Item 4.**Development Application: 20-26 Allen Street, Waterloo - D/2020/1426**

File No.: D/2020/1426

Summary Recommendation: The development application is recommended for deferred commencement approval.

Figure 35: Height exceedance for Buildings A and B

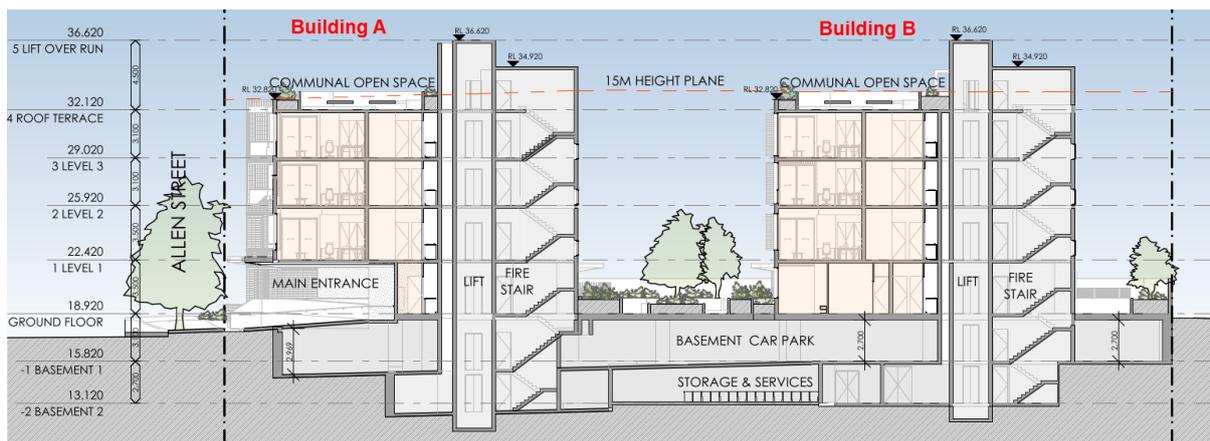
- 45. The site is subject to a maximum 'height of buildings' development standard of 15m. The proposed development is generally compliant, where the parapet of the buildings has a maximum height of 15m. This is exceeded by lifts, fire stairs and shade structures that service the rooftop open space areas and have a maximum height of 19.12m.
- 46. The variation is a maximum of 4.12m (27.4 per cent). The areas above the maximum 15m height plane, denoted by a red line, are identified in the sections shown in Figures 35 and 36 below.

- (iii) The main bulk of the proposed development is compliant with the 15m 'height of buildings' development standard and the maximum four-storey height recommended by Sydney DCP 2012 as shown in Figures 35 and 36 above. The proposed height is also consistent with the adjoining residential flat buildings to the east as shown in Figure 37 below.

- (iv) The areas of non-compliance are limited to lifts, fire stairs, and shade structures to the rooftop communal open spaces. These elements are set back from the street frontages to minimise visual impacts when viewed from the public domain to maintain the consistency in height and bulk with neighbouring developments.
- (v) The pattern of having similar height exceedance is also consistent with the residential flat buildings to the east, as shown in Figure 37 above. Furthermore, the proposed maximum height, being RL 36.62, is below the maximum heights of RL 37.07 for 707 Elizabeth Street and RL 37.4 for 713 Elizabeth Street that were previously approved and now implemented.

Figure 38: Building separation along the western boundary, and internally between buildings

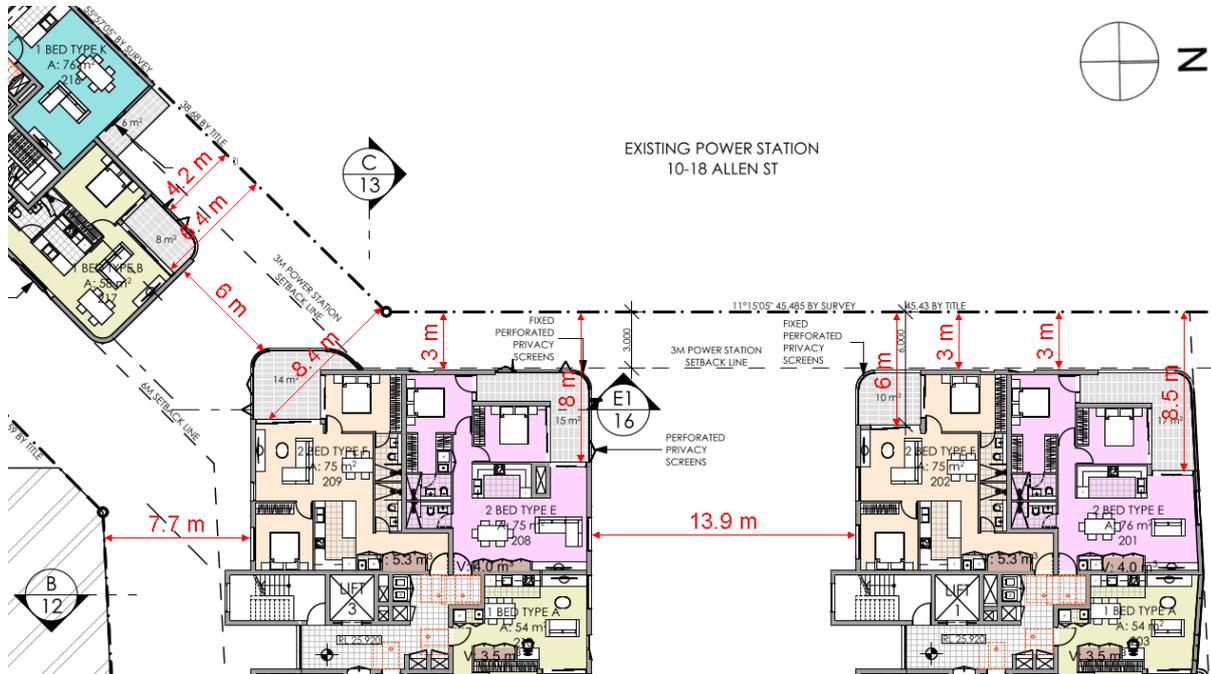
56. Type E and Type F apartments in Buildings A and B are located along the western boundary. As shown in Figure 38 below, the amended design has removed all openings to habitable rooms on the western elevation so that the Type E and Type F apartments do not rely on the western setback for ventilation or outlook from the bedrooms. These blank walls therefore do not require any additional setback from the western boundary beyond the 3m required for safety reasons. Any openings to the living areas of these apartments are otherwise provided with at least a compliant 6m setback from the boundary.

57. The amended design also provides fixed screens at the radius corners of the balconies (except the Type E apartments in Building A where the exposed corner would afford acceptable outlook north-west to Allen Street), with bi-fold screens along the western edge of each balcony. While balconies are considered to be habitable openings and a minimum 6m would typically be required, the reduced 3m separation to the substation would not result in unacceptable visual privacy impact, and the bi-fold screens allow future occupants to screen the outlook to the substation if desired and direct outlook from the balconies to the north and south.

59. While the balconies have a reduced setback of 4.2m to the western boundary, the reduced setback to the substation will not result in unacceptable privacy impacts or restrict outlook to the sky. Such outlook would not be significantly improved by requiring a 6m setback and is therefore not pursued in this instance. Notwithstanding, a solid balustrade is provided to the western edge of each balcony to screen any downward view to the substation. Bi-fold screens also provide future occupants the option to screen the outlook to the substation if desired, and privacy protection if the substation is redeveloped in the future.

61. As shown in Figure 38 above, the balcony of Type F apartments in Building B and the balcony of Type B apartments in Building C are provided with a separation of 6m.
62. While typically a distance of 12m would be required, the design has been amended to provide a blade wall to the balcony of Type B apartments to create a blank wall scenario, so that only a 6m separation is required. Fixed screens will also be provided to the radius corners of the balcony of Type F apartments for added privacy protection.

Figure 39: Type K apartment in Revision B

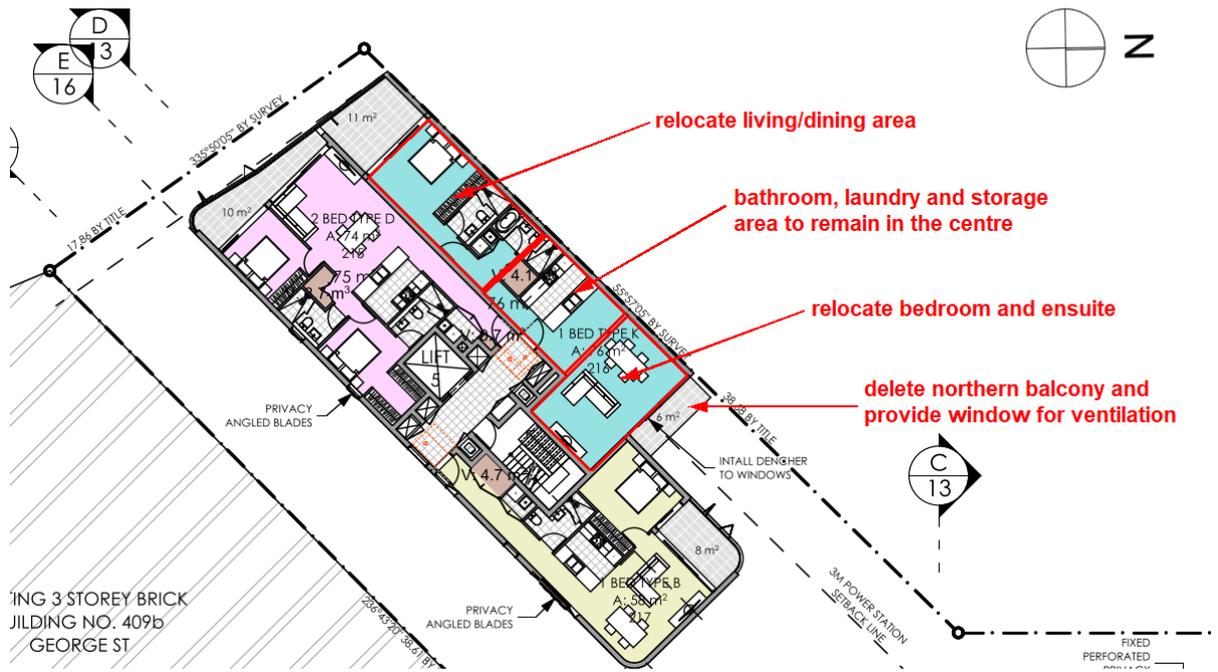
72. The Type K apartments in Building C are cross-through apartments, with a width of 3.8m internally at the southern portion. The amended design (Revision D) modified Type K into a one-bedroom apartment, with a secondary north-facing balcony. Following discussion with the City's Urban Designer, a condition is recommended to:

- (a) delete the northern balcony, which would resolve the privacy concern with the Type B apartments
 - (b) swap the location of the bedroom and the combined living/dining area so that the living/dining area can obtain better outlook to George Street and has a better relationship with the adequately sized balcony.

73. The amendment sought, as illustrated in Figure 39 above, is to ensure that:
- design scheme does not include a north-facing balcony, which is an element not expressed supported by the updated fire safety assessment and EMF assessment, and is an element that Ausgrid has previously raised concern about; and
 - the living/dining area of the apartments have direct access to a balcony, and an acceptable outlook to George Street.
74. While the amendment sought would still be a numerical non-compliance with the 4m width for cross-through apartments, it exceeds the 3.6m width otherwise recommended for a one bedroom apartment, and the dual aspect nature of Type K also allows natural light and cross ventilation to address amenity concerns typically associated with a deep narrow layout.

Figure 42: Location of the ground floor apartment at 713 Elizabeth St impacted by the proposed development

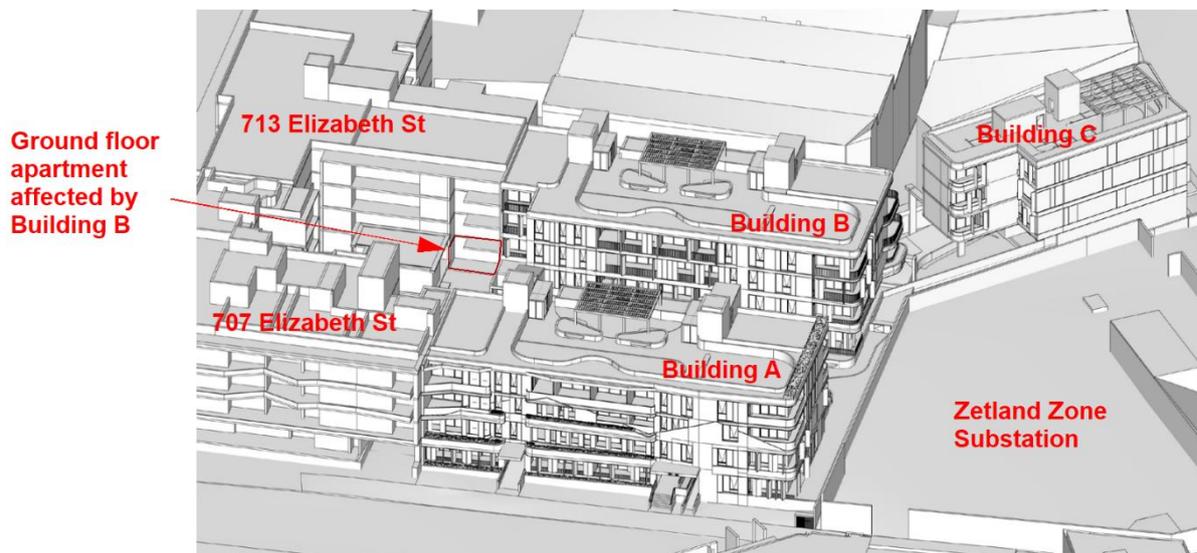
88. The proposed development will impact on one ground floor apartment (Figure 42), resulting in its private open space receiving less than two hours of direct sunlight. As a result, the number of apartments achieving the recommended two hours of solar access is reduced by one, to a total of 23 apartments, or 62.1 per cent. The overshadowing impact is caused by the building bulk of Building B that is compliant with the maximum building height, and the reduction is within the maximum 20 per cent reduction allowable under Part 3B-2 of the ADG. The impact has also been minimised by providing a setback to the eastern boundary despite a setback is not typically required for a blank wall scenario. Therefore, the impact is considered reasonable.

89. The report also demonstrates that currently eight apartments (21.6 per cent) receive no direct sunlight. The proposed development will not increase that number.

Figure 43: Sun's eye diagram at 9am demonstrating the overshadowing impact to developments on the western side of George Street

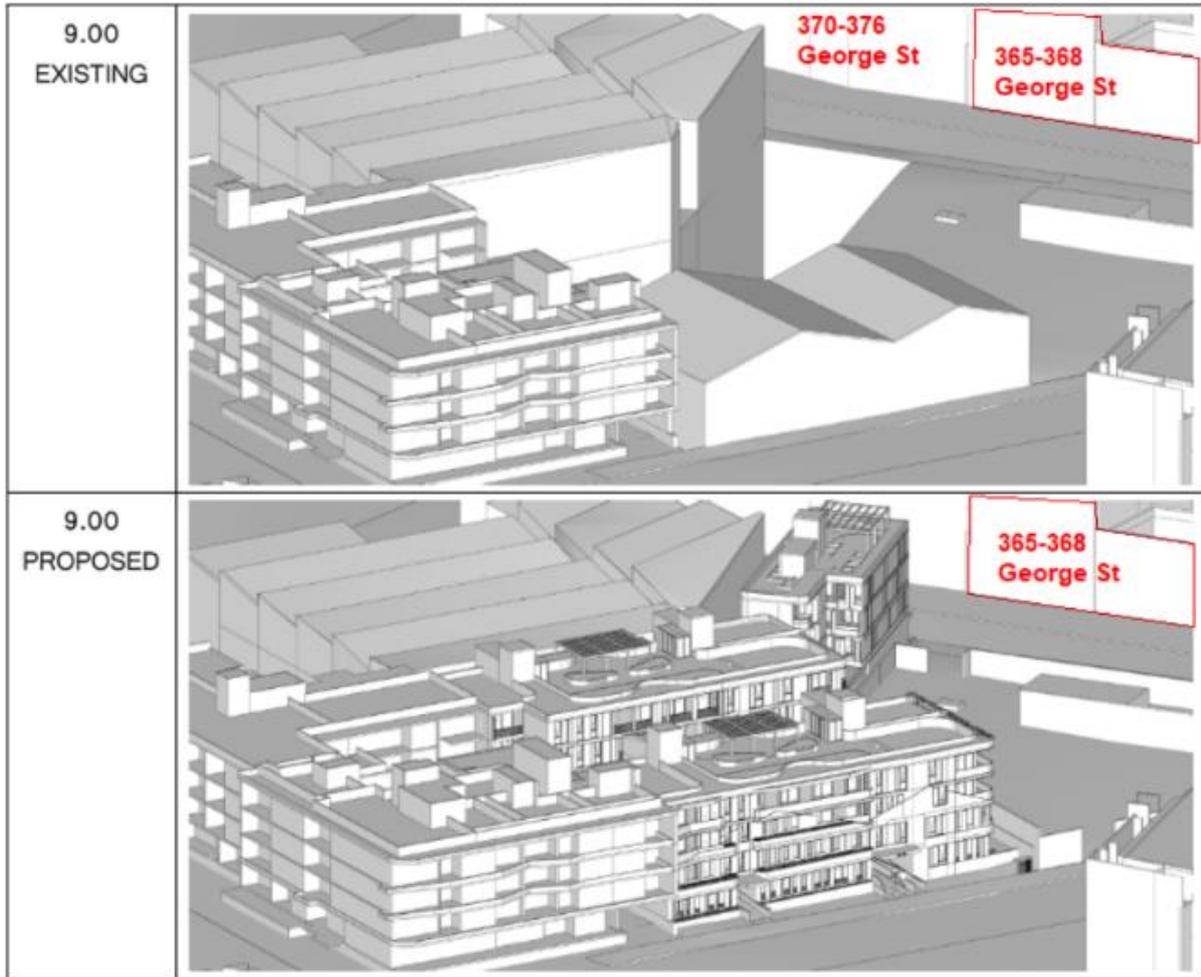
90. A submission was received raising concern of overshadowing by Building C to the George Street facing apartments of 365-368 George Street. The overshadowing diagrams included in Attachment B2 demonstrates that the development could potentially impact 365-368 George Street and 370-376 George Street between 9am and 10am.
91. The sun's eye diagrams included in the solar analysis report, reproduced in Figures 43-44 below, further confirms that there is no impact to 365-368 George Street, and the impacts to 370-376 George Street are limited to before 10am. This allows the George Street facing apartments to continue to receive at least two hours of direct sunlight to the balconies, living area windows, and other bedroom windows between 9am and 12noon.
